Architectural Review Board

Meeting Minutes

March 11, 2019

Architectural Review Board Staff Report March 11, 2019 Meeting

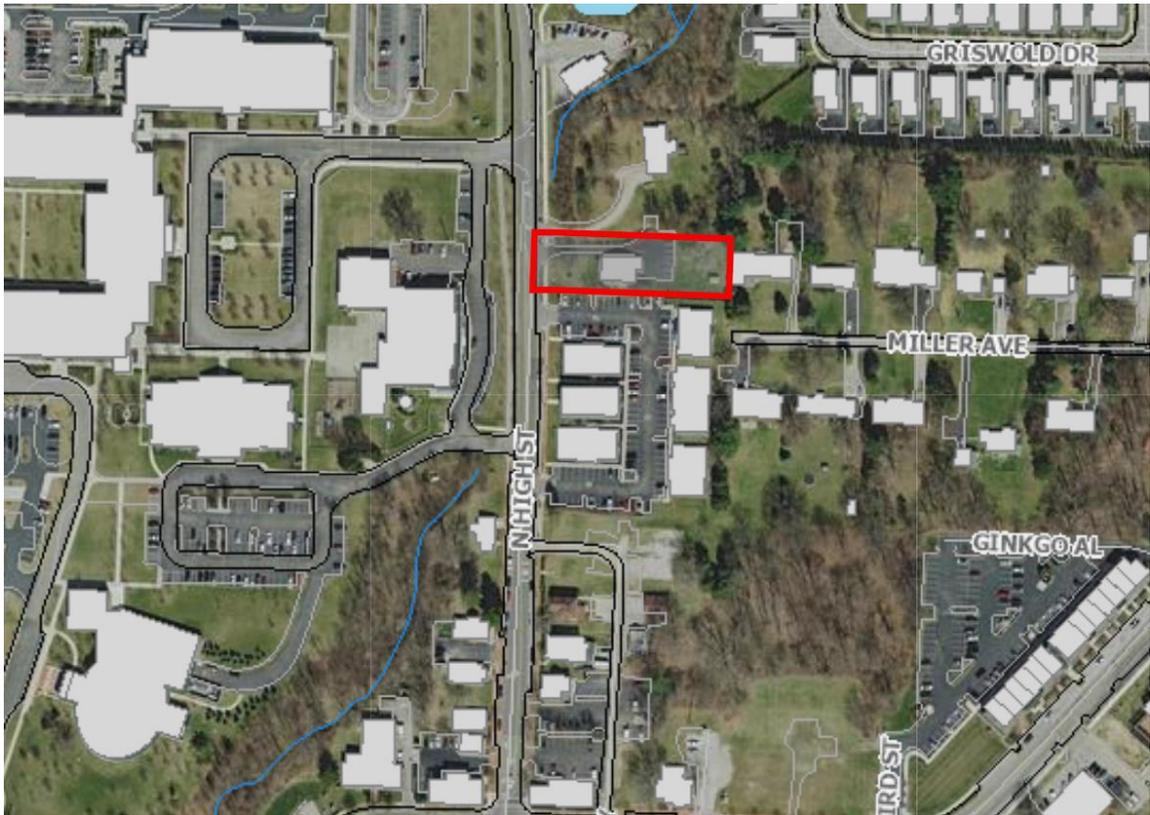
Mr. Hinson asked if the picture is showing a brick wall.

Mr. Hinson asked if the landscaping detail being continued to the north.

Mr. Strahler asked if the planting will be touching at the time of installation.

Mr. Hinson stated that they should be touching at the time of installation. Asked what the height requirement is.

- g. Additionally a hedgerow will be installed in the front yard of the Animals-R-Special property. Please see a rendering below:

Mr. Mayer stated that it is a shrub wall. The business owner was concerned that her building is far off of the road. We decided that adding the street presence with the shrub wall would help bring the site to the front and create an alignment.

Mr. Mayer stated that the shrub wall will align with the building to the north.

Mr. Mayer stated that code allows the plantings 5 years to reach maturity. The screening is required to be installed at 3.5 foot tall. Being a city project we will try to find the largest material for installation.

2. A 3.5-foot tall evergreen shrub will be installed surrounding the parking lot to provide for headlight screening of the parking lot, where it is adjacent to residential homes. The evergreen shrubs shall be 3.5' tall and touching at installation.
